**RE: Septic Plan_Woodbine Crossing, Lot 6
 731 Woodbine Crossing Road
 Mount Airy, MD 21771**

The following comments pertain to the Septic Plan (LPD Design) for 731 Woodbine Crossing Road.

ON SITE SEWAGE DISPOSAL SYSTEM DESIGN PLAN

LOT 6
WOODBINE CROSSING
PLAT No. 20055
731 WOODBINE CROSSING ROAD
FOURTH ELECTION DISTRICT
HOWARD COUNTY, MARYLAND
SCALE: 1" = 30' JANUARY, 2017

TRENCH DESIGN

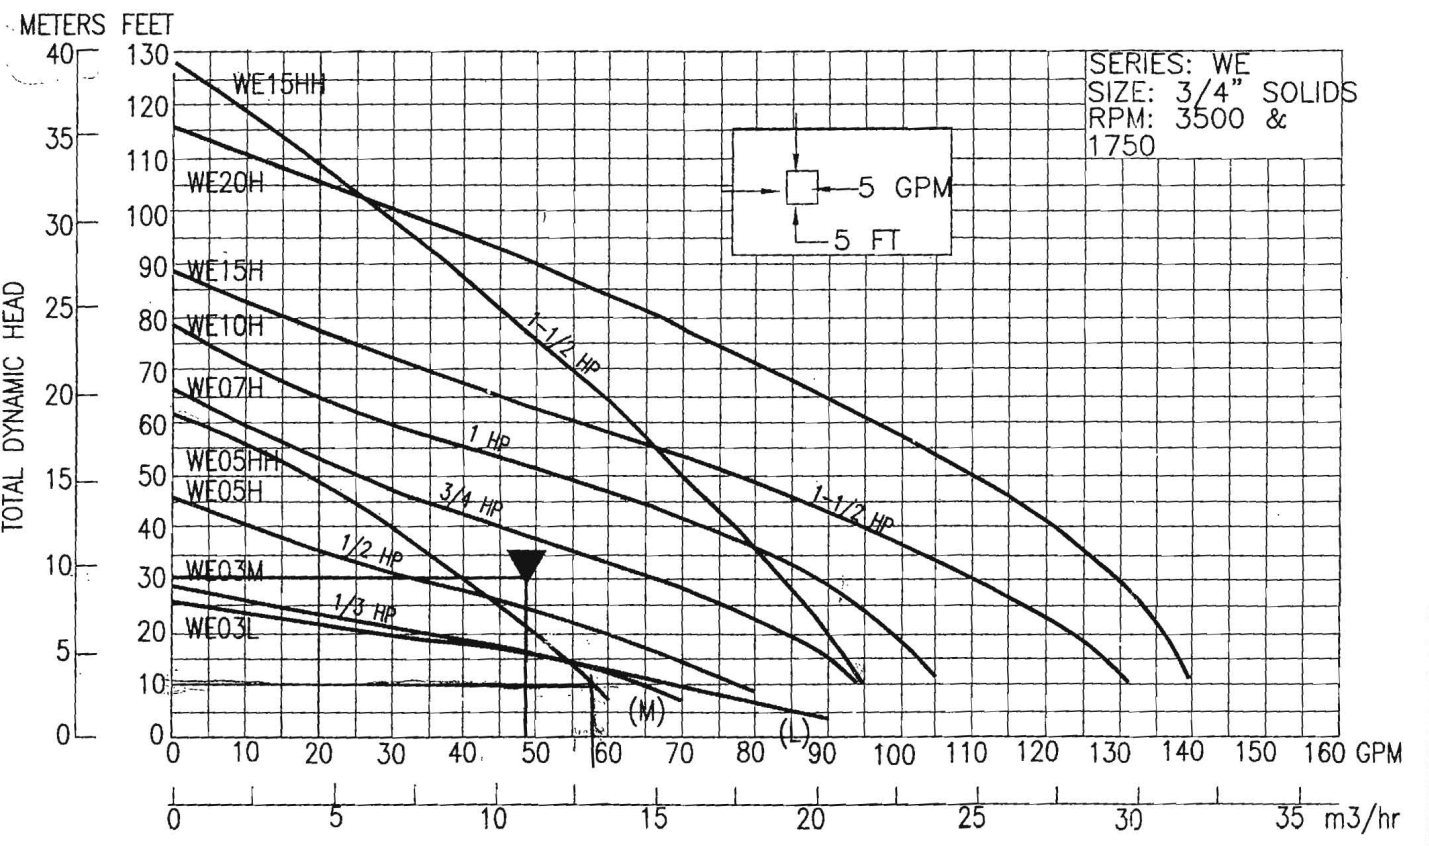
- 1.) The ground & pipe invert elevations on the charts do not match. You could keep the pipe invert elevations the same and change the # of perforations to arrive at 44 ft. of trench/lateral.

Low Pressure Dosing System										
	Ground. Elevation	Pipe Inv.Elv.	Trench Length	Pipe Length	Perf. Dia.	Head	Perf. F.R.	Perf. Spac	#of Orf	Lateral F.R.
L1	670	666	44	42.15	5/16	3	1.99	3.7	12	23.88
L2	670	666	44	42.15	5/16	3	1.99	3.7	12	23.88
L3	669	666	44	42.15	5/16	3	1.99	3.7	12	23.88
L4	669	666	44	42.15	5/16	3	1.99	3.7	12	23.88
										95.52 GPM

Trench Length = 3.7 ft. x 12 Orifices = 44 ft. (6 orifices x 3.7 = just 22.2 ft of lateral)
 Lateral Length = 44 - (3.7/2) = 42.15 ft.
 Trench Flow Rate = 23.88 + 23.88 + 23.88 + 23.88 = 95.52 gallons/minute

HYDRAULIC GRAPH

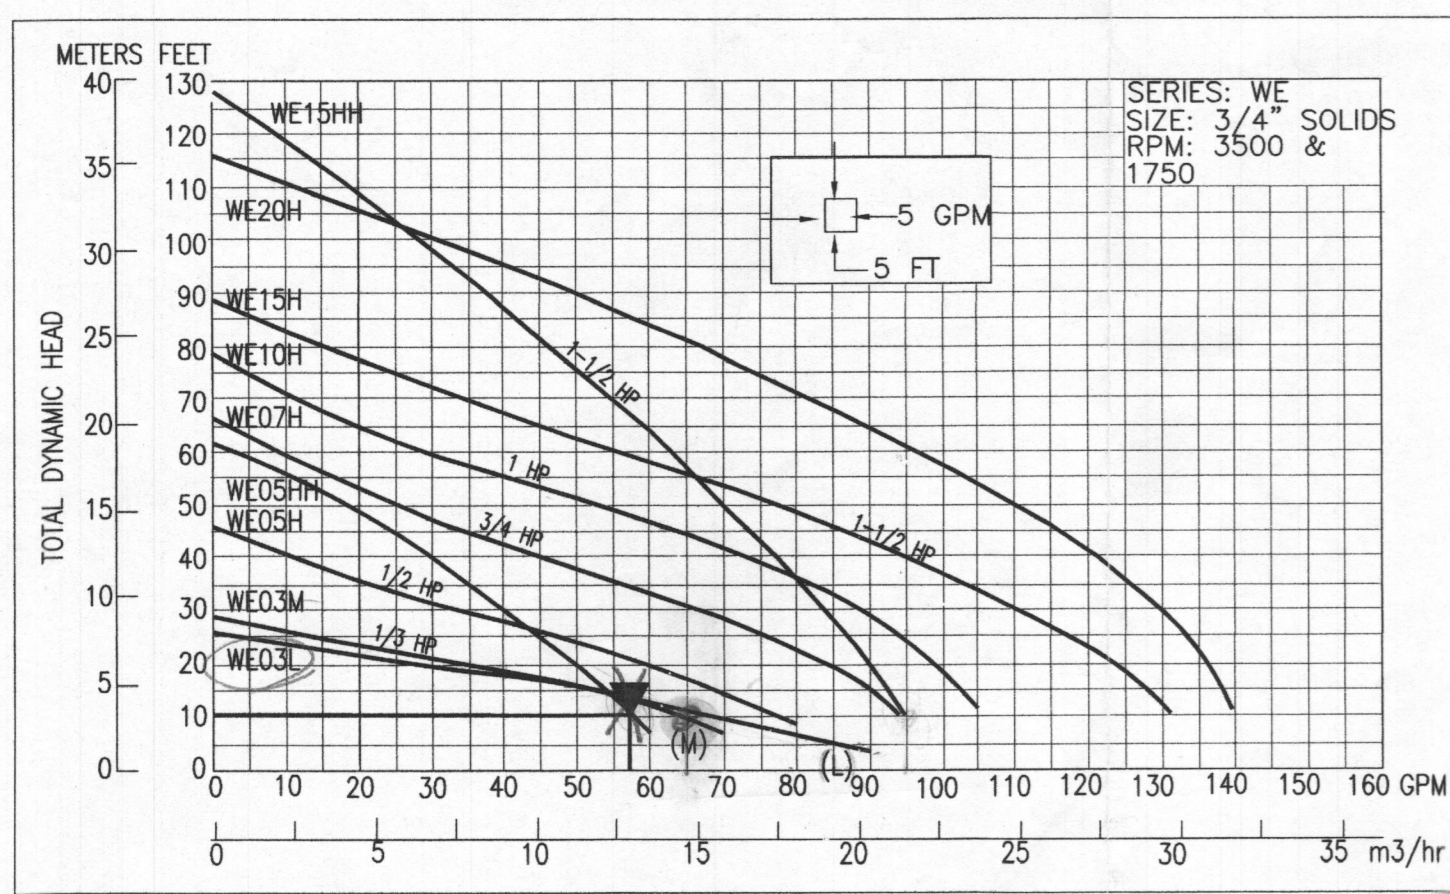
- 3.) Friction Head = 110 ft. + 39 ft. = 139 ft. x 2.09 (chart# at 95.52) = 290.51/ 100 = 2.91ft
 Static Head=Pump Off to Upper Trench = 4.44 ft.
 Distal Head = 3 ft. TDH = 2.91+4.44+3=10 @ 57 GPM
 Runtime=195.4 gallons (min does volume)/57GPM=3.43 min
 Pump =WE05HH (Please Note: Point on graph was incorrect; it was graphed in meters instead of feet)

FRICTION HEAD = 110' + 39' = 149' x 2.09 = 311.141 / 100 = 3.11'
STATIC HEAD = PUMP OFF TO UPPER TRENCH = 4.44'
DISTAL HEAD = 3.00'
TOTAL DYNAMIC HEAD (TDH) = 10.5 @ 57 GPM
